BRUNSWICK STEAM ELECTRIC PLANT, UNIT NO. 1

AMENDMENT TO FACILITY OPERATING LICENSE

Amendment No. 29
License No. DPR-71

SAFETY EVALUATION BY THE OFFICE OF NUCLEAR REACTOR REGULATION

Figure 3.2.1-1

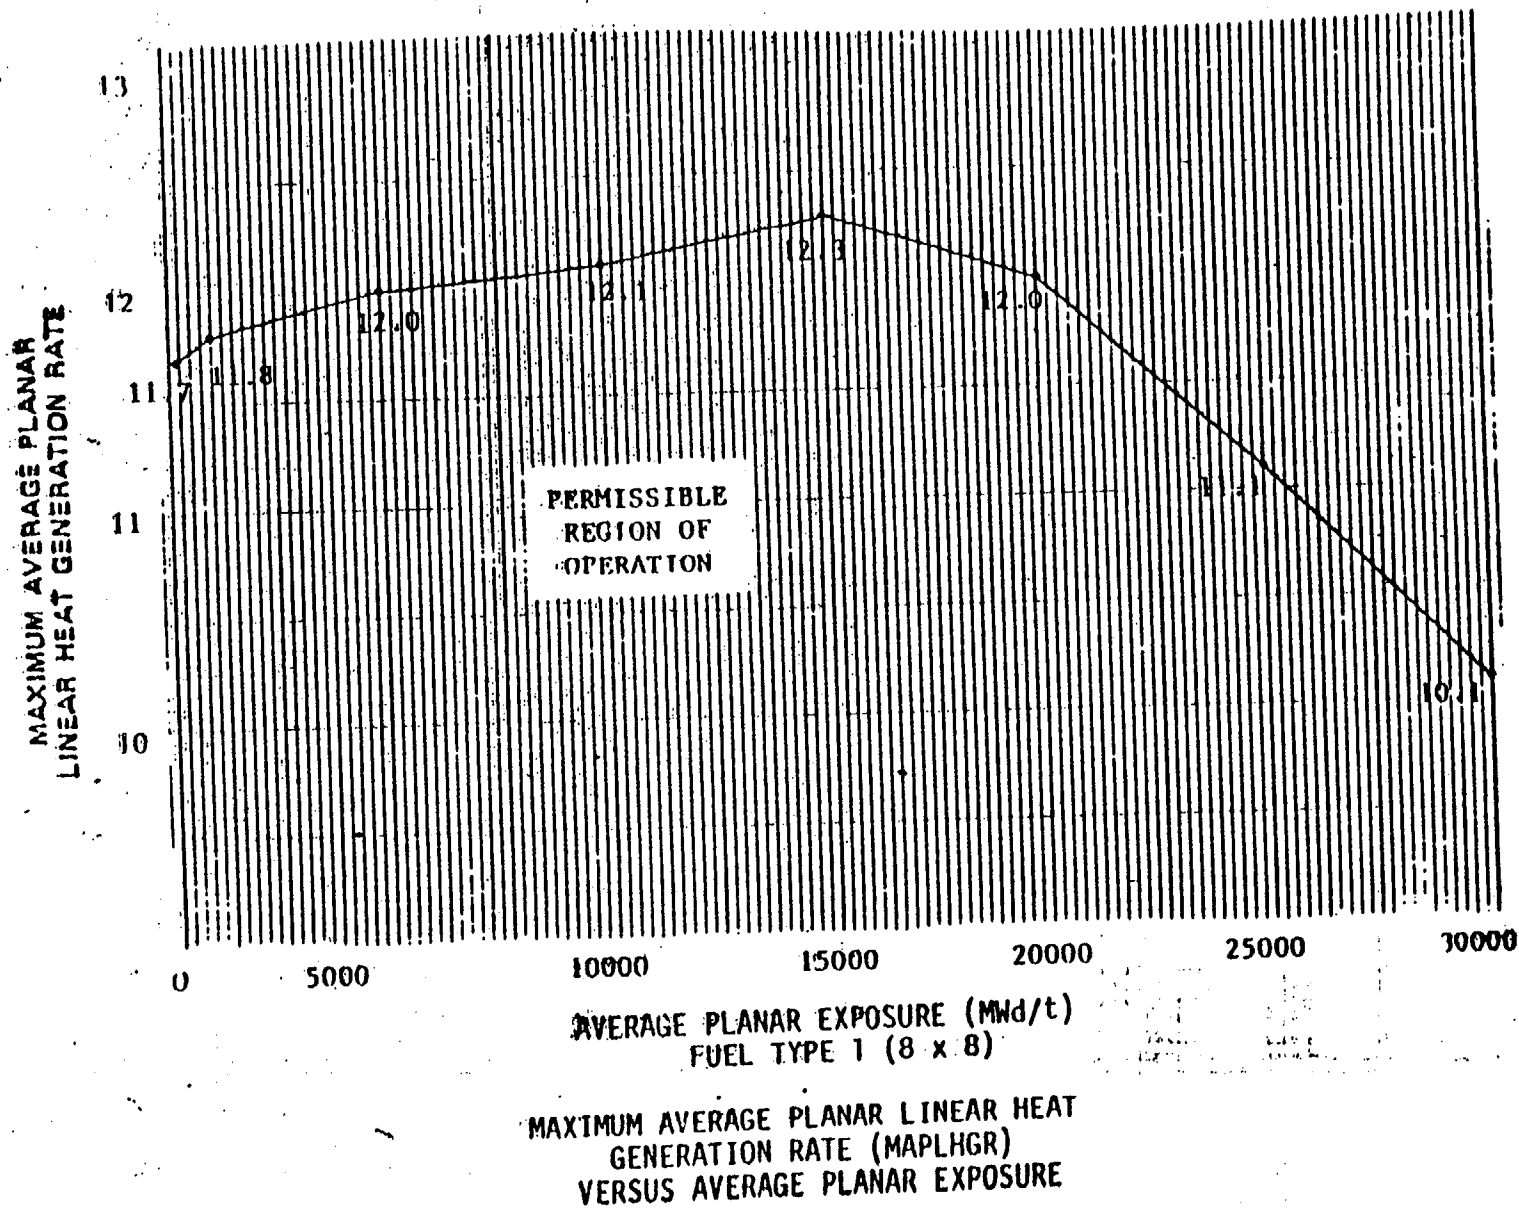
3.2.1 All AVERAGE PLANAR LINEAR HEAT GENERATION RATES (APLHGR's) for each type of fuel as a function of AVERAGE PLANAR EXPOSURE shall not exceed the limits shown in Figures 3.2.1-1, 3.2.1-2, 3.2.1-3, 3.2.1-4, 3.2.1-5 or 2.3.1-6.

With an APLHGR exceeding the limits of Figure 3.2.1-1, 3.2.1-2, 3.2.1-3, 3.2.1-4, 3.2.1-5 or 3.2.1-6, initiate corrective action within 15 minutes and continue corrective action so that APLHGR is within the limit within 4 hours or reduce THERMAL POWER to less than 25% of RATED THERMAL POWER within the next 4 hours.

FIGURE 3.2.1-4

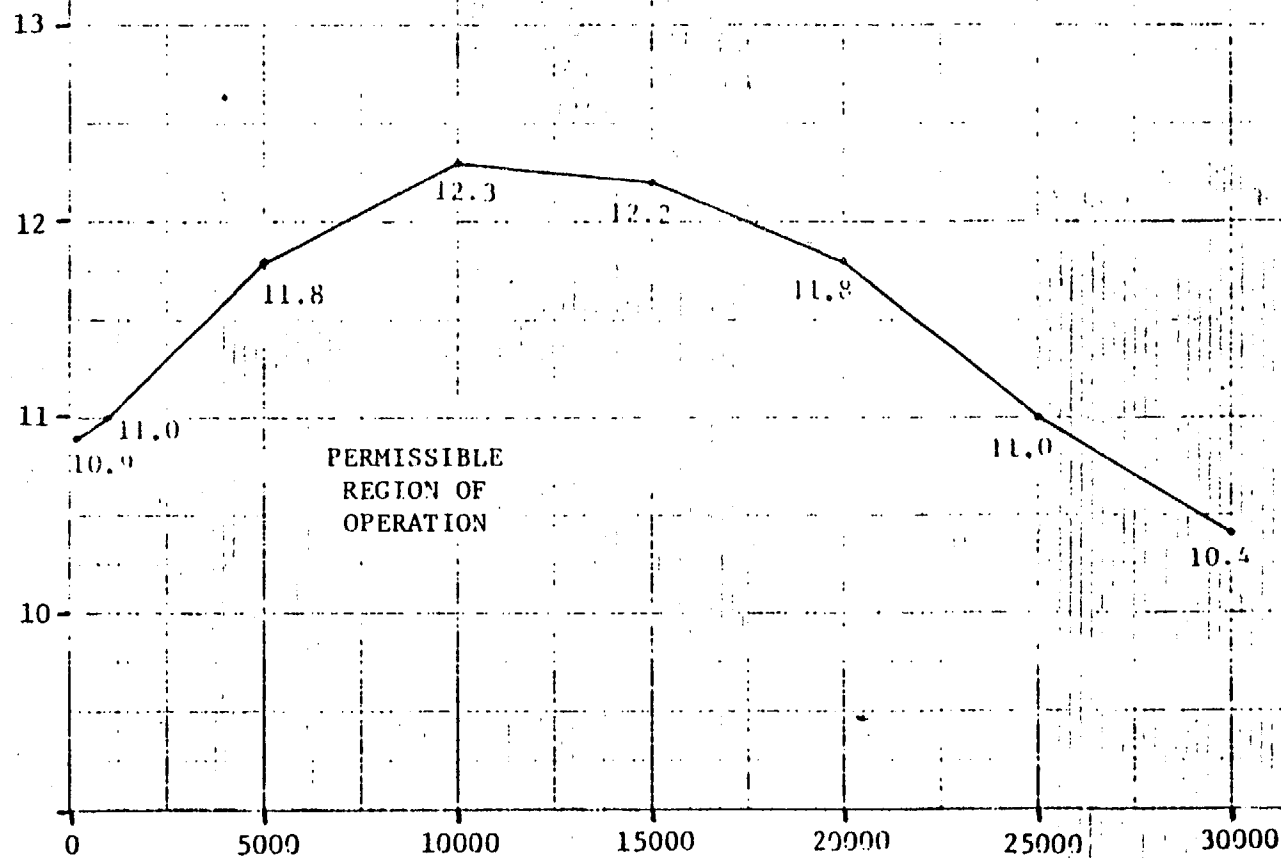
The peak cladding temperature (PCT) following a postulated loss-of-coolant accident is primarily a function of the average heat generation rate of all the rods of a fuel assembly at any axial location and is dependent only secondarily on the rod to rod power distribution within a assembly. The peak clad temperature is calculated assuming a LHGR for the highest powered rod which is equal to or less than the design LHGR corrected for densification. This LHGR times 1.02 is used in the heatup code along with the exposure dependent steady state gap conductance and rod-to-rod local peaking factor. The Technical Specification APHGR is this LHGR of the highest powered rod divided by its local peaking factor. The limiting value for APLHGR is shown in Figures 3.2.1-1, 3.2.1-2, 3.2.1-3, 3.2.1-4, 3.2.1-5 and 3.2.1-6.

FIGURE 3.2.3-1

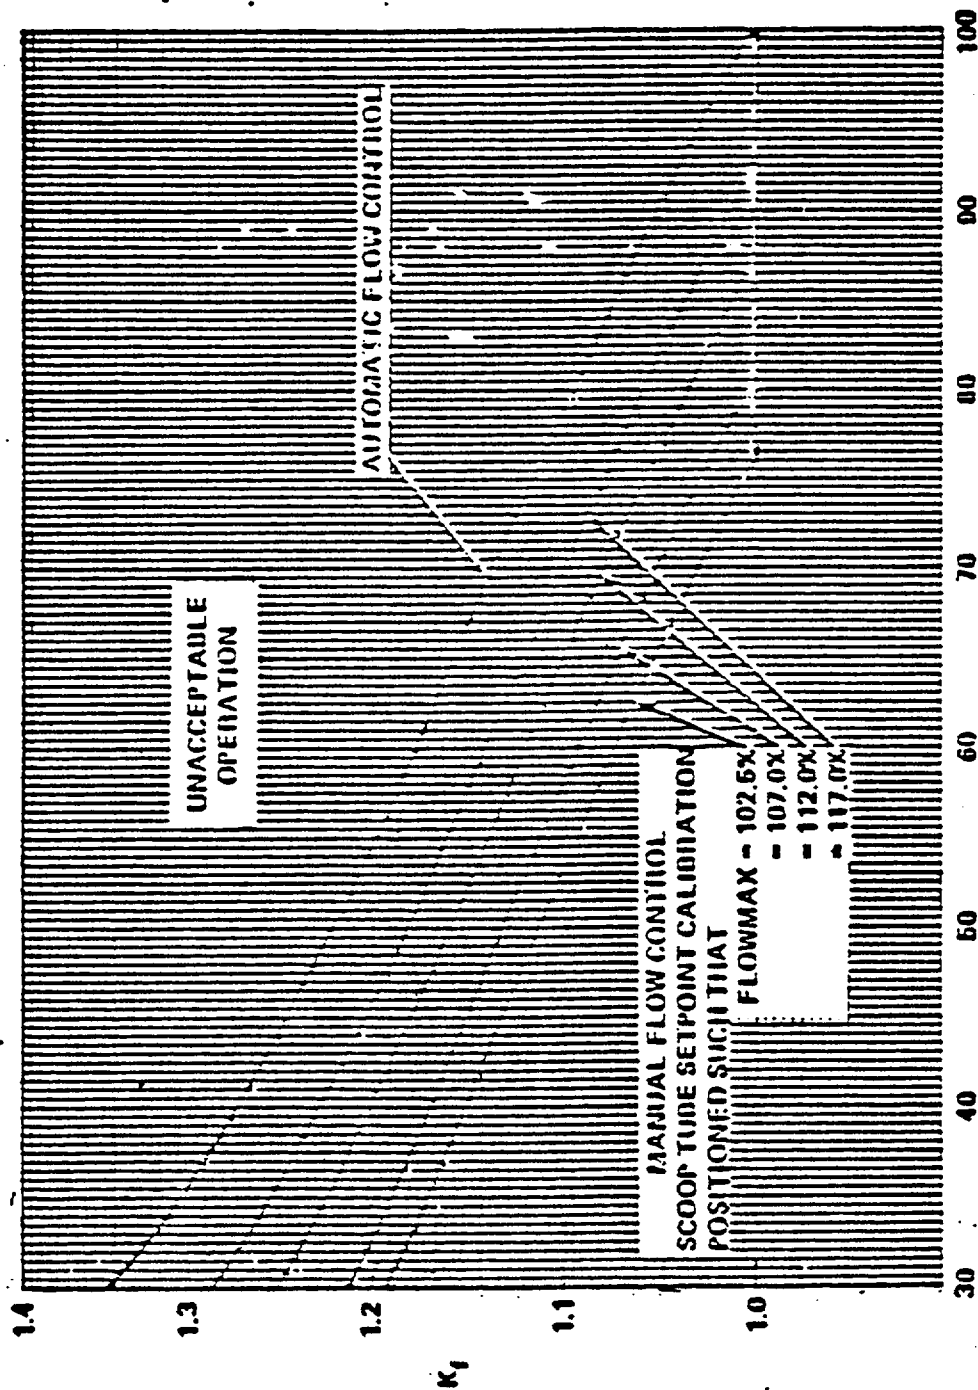
3.2.3 The MINIMUM CRITICAL POWER RATIO (MCPR), as a function of core flow, shall be equal to or greater than MCPR x the K_f shown in Figure 3.2.3-1 where MCPR values are:

<u>BOC3* to EOC3** -2000 MWD/t</u>	<u>EOC3-2000 MWD/t to EOC3</u>
8x8 fuel	1.24	1.30
8x8R fuel	1.24	1.30
P8x8R fuel	1.30	1.32

The K_f factor values shown in Figure 3.2.3-1 were developed generically which are applicable to all BWR/2, BWR/3, and BWR/4 reactors. The K_f factors were derived using the flow control line corresponding to rated thermal power at rated core flow.
